**Cover Letter and Notice of Alteration
Assessment - Removal of Chiller
Minnedosa Ethanol Plant
Manitoba Conservation License No. 2698R**

May 2022

**Re: Cenovus (formerly Husky Oil Operations Limited)
Minnedosa Ethanol Plant
Manitoba Conservation Licence No. 2698R
Proposed Alterations to Ethanol Plant – Chiller Removal**

Figure 1 - Diagram Showing Existing and Proposed Process Changes Near the Absorber (T-406)

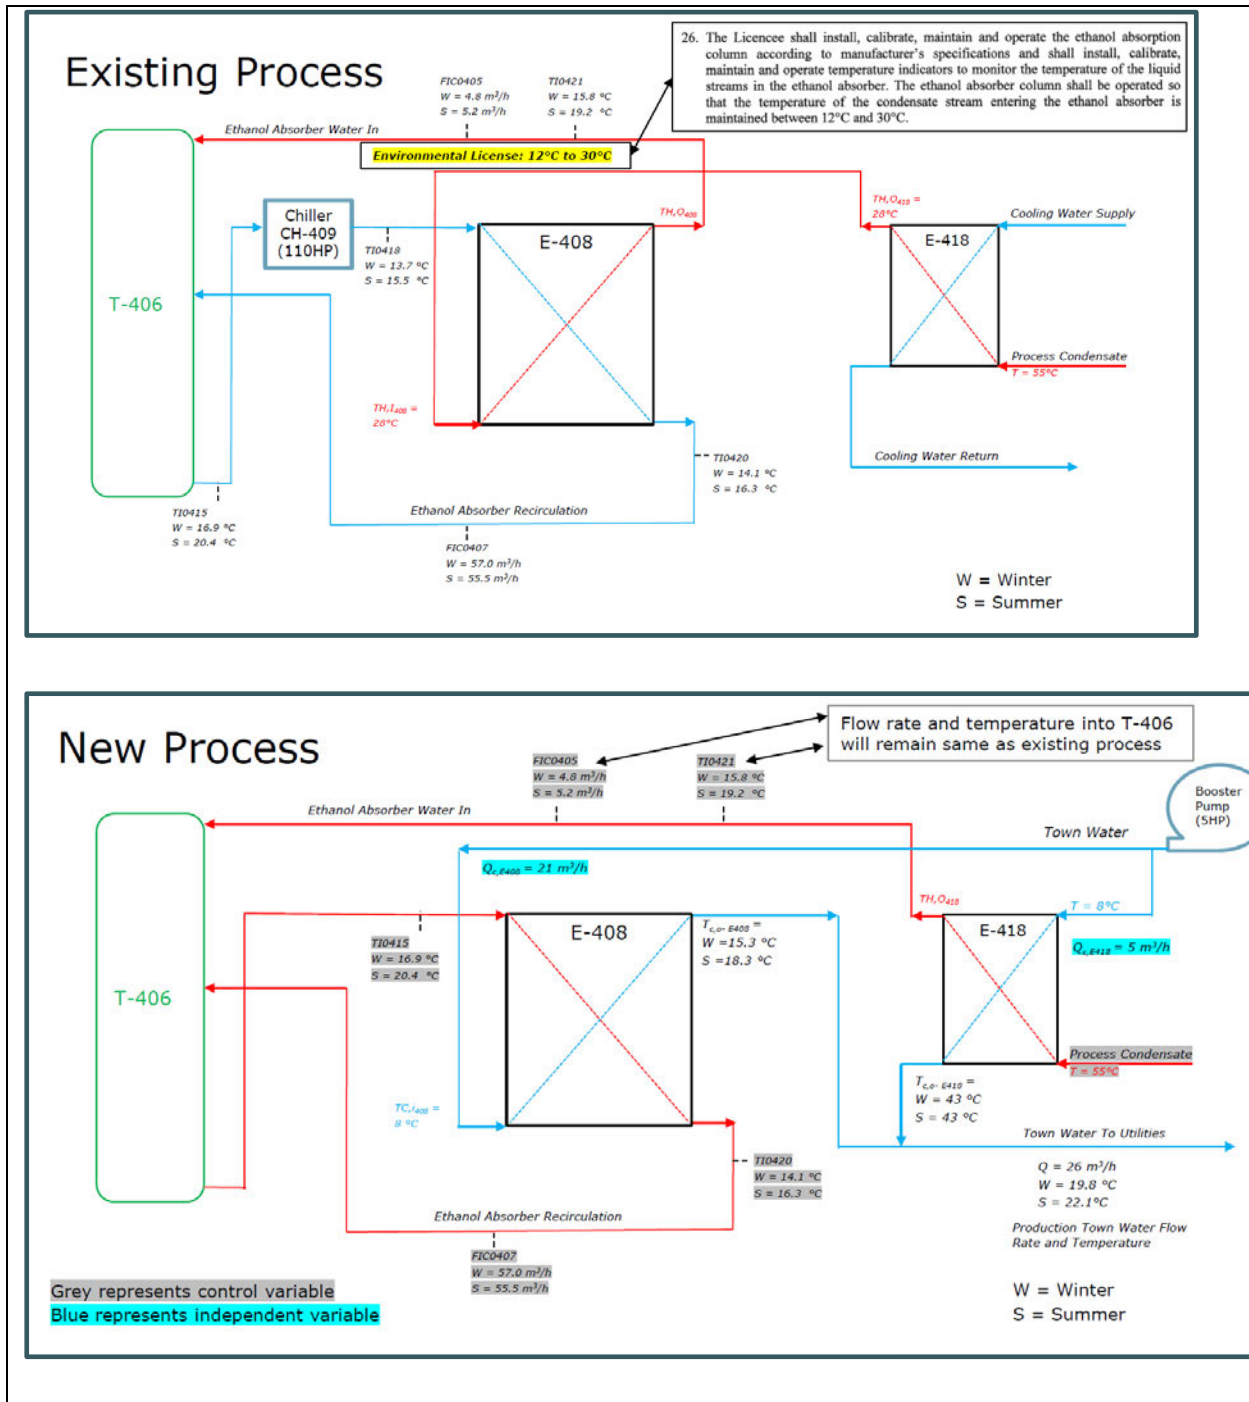
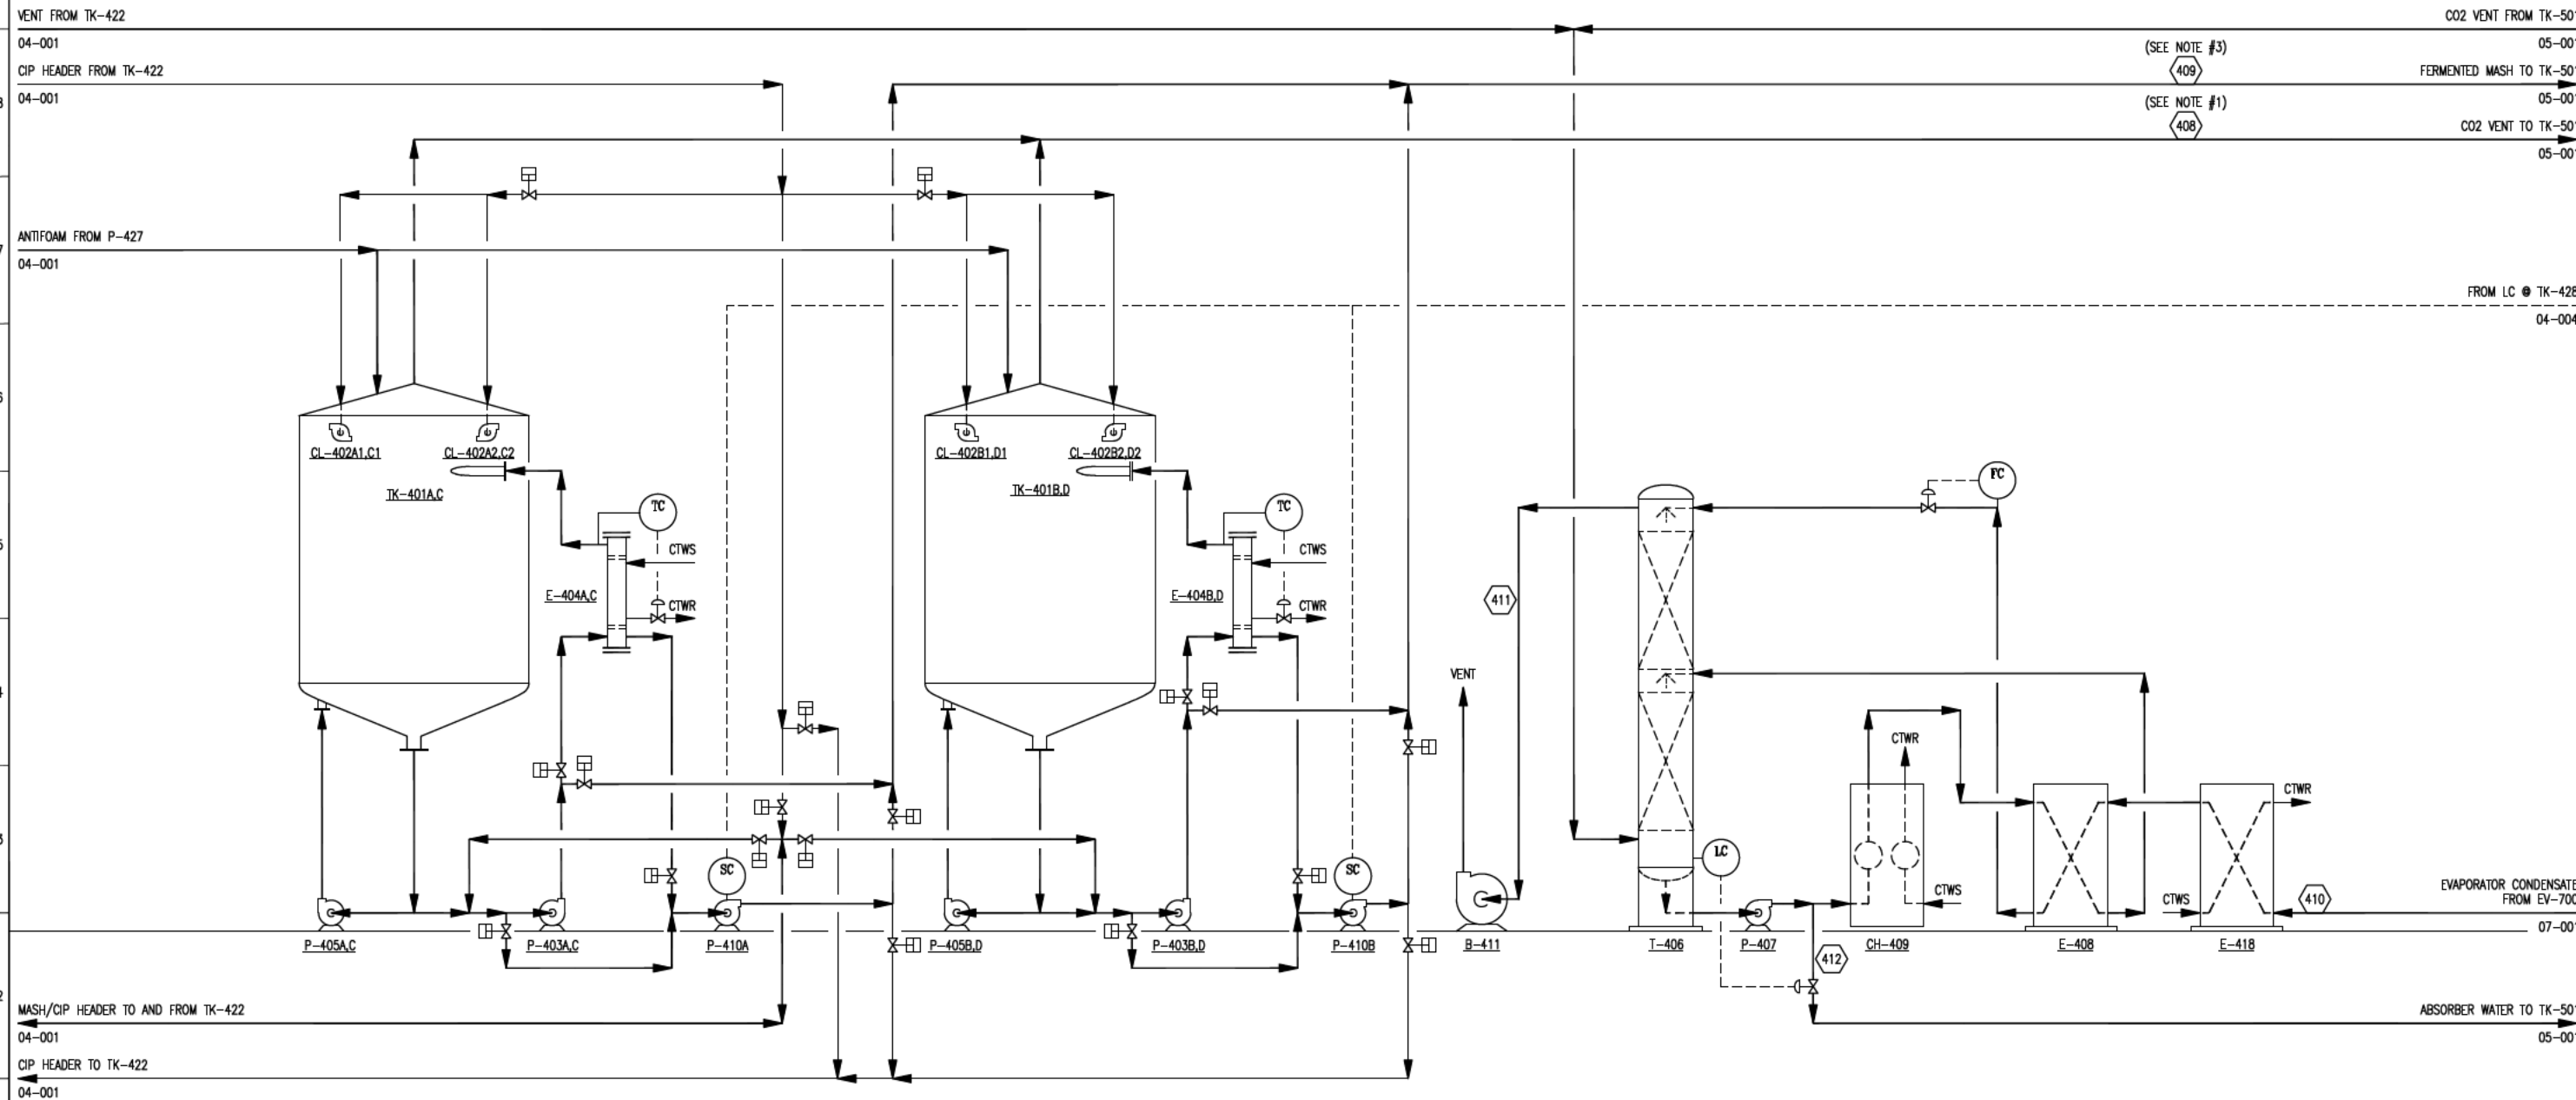
A detailed explanation of the proposed alteration and license amendment request follows. Figure 1 provides a high-level summary of the existing and proposed processes. The proposed process flow diagram is presented in Attachment A.

Figure 1 provides a description of the new ethanol recovery process. The project scope includes the removal of the chiller (CH-409) and minor changes to process piping to (1) re-route the absorber effluent (T-406) directly to heat exchanger E-408 and (2) direct heated Town water from heat exchangers E-408 and E-418 to the Utilities building. No additional tankage or additional process modifications will be required. The new process flow diagrams are provided in Attachment A.

Condition 26 of the license prohibits the condensate stream inlet temperature to be below 12°C. Therefore, to facilitate the proposed process change Cenovus is requesting that condition 26 be amended to allow for the temperature of the liquid stream entering the absorber to not exceed 30°C rather than the existing temperature range (i.e., 12°C to 30°C). With this proposed change, Condition 26 would read as follows:

26. The licensee shall install, calibrate, maintain and operate the ethanol absorption column according to manufactures specifications and shall install, calibrate, maintain and operate temperature indicators to monitor the temperature of the liquid streams in the ethanol absorber. The ethanol absorber column shall be operated so that the temperature of the condensate stream entering the absorber does not exceed 30°C.
